From: D Rose
Sent: Monday, January 1, 2024 5:51 PM
To: Figueira, Pearl; [Pln - CC - Development Dc](#)
Cc:
Subject: Comment on Planning Application 23/00882/FULL

Happy New Year, please accept the following comment on the planning application for the City of London Police Base at Middlesex Street Estate.

New Comment on Planning Application 23/00882/FULL

For illustration: sketch map showing main motor vehicle routes to/from the estate, with direction of travel highlighted in red and areas of main congestion / limited access routes shaded in yellow:

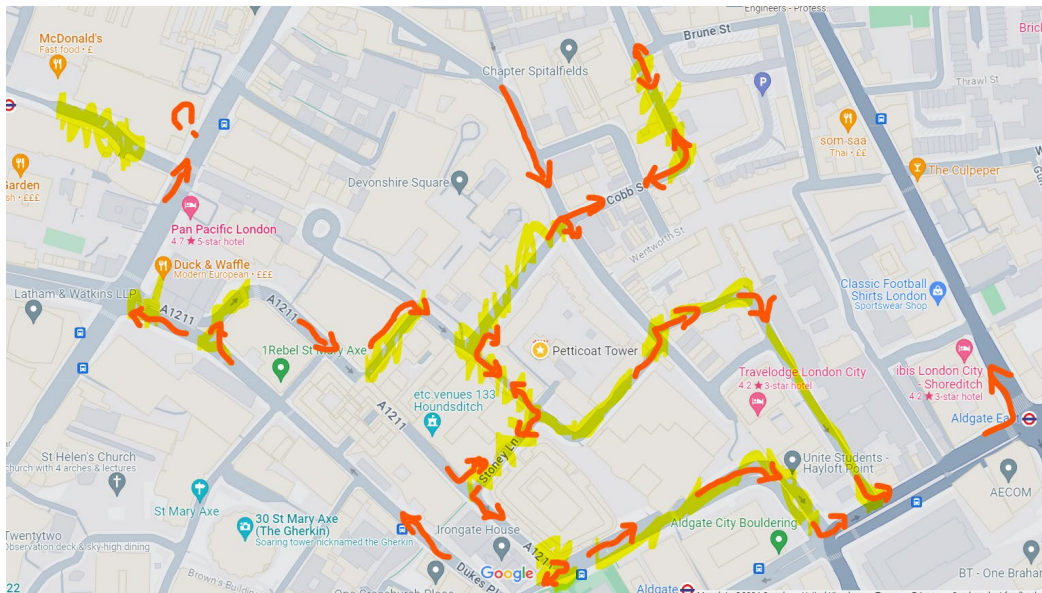
As a resident and regular commuter to and from the estate I can say with experience that the above marked routes regularly cause inconvenience or frustrations for the day-to-day motorist. I am concerned about the future effect of the development and knock-on issues for traffic, not just for local residents and services, but for police vehicles performing essential public service or emergency response.

- Middlesex Street via Bishopsgate** – which is problematic as one way and typical vehicle traffic is restricted during weekdays on Bishopsgate, or totally blocked due to market trading on Sundays. Southern end of Middlesex Street is blocked to motor vehicle traffic.

- Cutler Street or Stoney Lane via Houndsditch** – problematic as Houndsditch and Cutler Street are both one way, and are likely to be disrupted severely over the next few years due to demolition and construction works of a major commercial office building at 115 Houndsditch. Further development of this area with similar consequences for road traffic can be anticipated. If Stoney Lane becomes main access route then space is already limited by parking bays along one side of the street and pinch points at:

- Artizan Street / White Kennett Street / Harrow Place.** The roads here are narrow and regularly blocked by traffic such as food delivery or laundry lorries waiting and loading outside the Travelodge, as well as existing police vehicles. The result is blind corners which present a danger to pedestrians, drivers and cyclists, or obstructed carriageways and narrow pavements with no passing spaces and pedestrians often walking in the road.

- Houndsditch / St Botolphs Street.** Due to the one way system and blocking of the

southern end of Middlesex St, the only route back into the City from the Estate is via St Botolphs' Street via Aldgate, which is interrupted by several traffic lights and is often slow. Alternatively, one can take a very hard right turn on the corner next to Tesco Metro, towards Bevis Marks. This is the most convenient route back to London Wall, Bishopsgate, etc, but presents a very awkward corner, given the angle and potential for oncoming traffic, but also complicated by pedestrian crossings, a bike lane and bus stands.
